The Regular Meeting of the
BRIAN HEAD TOWN
PLANNING COMMISSION
56 N. Hwy 143, Brian Head, UT 84719
Via Zoom Meeting ID# [899 4597 2919](https://zoom.us/j/89945972919)
www.zoom.us
Tuesday, June 15, 2021 @ 1:00 p.m.

1. SCHEMATIC PLAN REVIEW – SHANGRI LA LODGE

STAFF REPORT TO THE PLANNING COMMISSION

SUBJECT: Shangri La Schematic Plan Review
AUTHOR: Wendy Dowland
DEPARTMENT: Administration
DATE: June 15, 2021
TYPE OF ITEM: Administrative Direction

**ARCHITECTURAL
SITE PLAN**

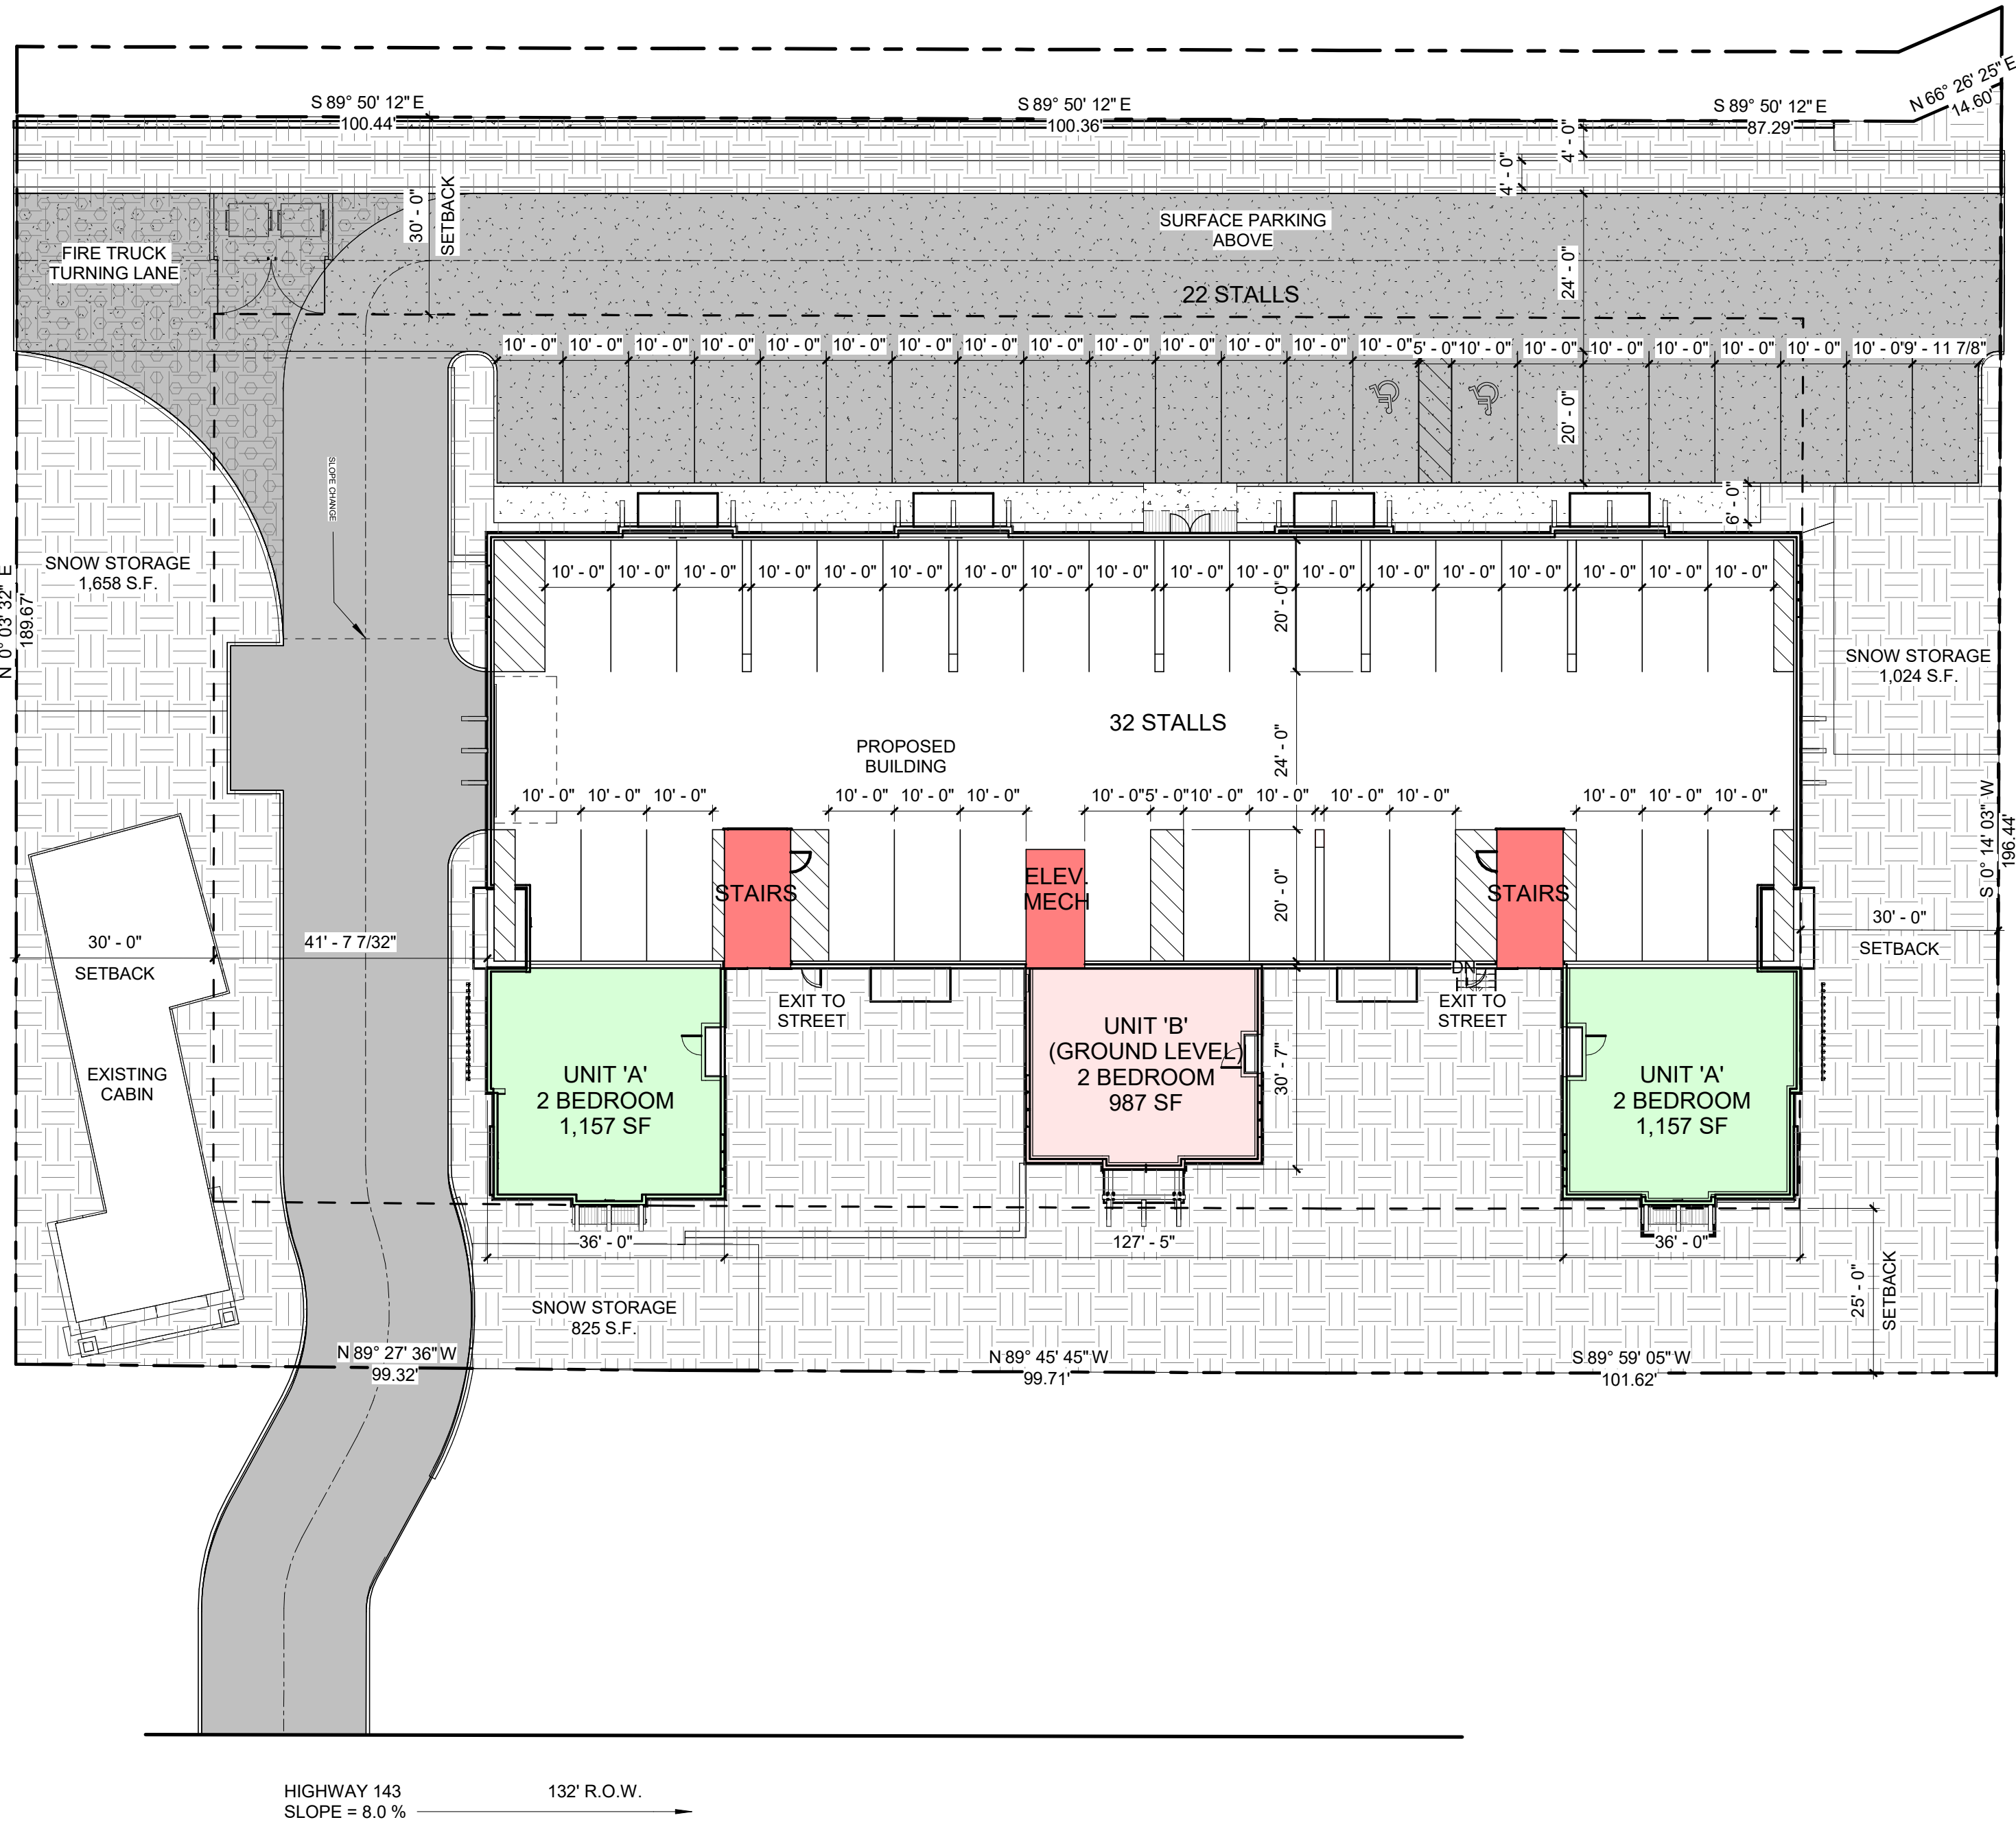
- vii. Minimum landscaping is 40%, the proposal would have roughly 3,507 square feet of snow storage (6%), 16,000 square feet of parking and driveways (27%), with the remaining property having a combined landscaped and undisturbed area of 36%. Staff would like the Commission's input regarding whether or not the snow storage areas or driveway is considered landscaping.

- viii. Parking requirement is 55 spaces, the proposal includes a count of 32 stalls within the parking garage and 23 exterior parking spaces.
 - c. International Building Code (IBC) is the applicable building code adopted by the state and the town, and it will be applied to this project by the Iron County Building Department.

- viii. Roads: Access to the property will be from Driftwood Drive. The existing road will need to be brought to the Town's standards.
 - ix. Driveways: Driveways and parking for this project will require hard surface as required by code. The proposed 2-way drive is 25' wide.
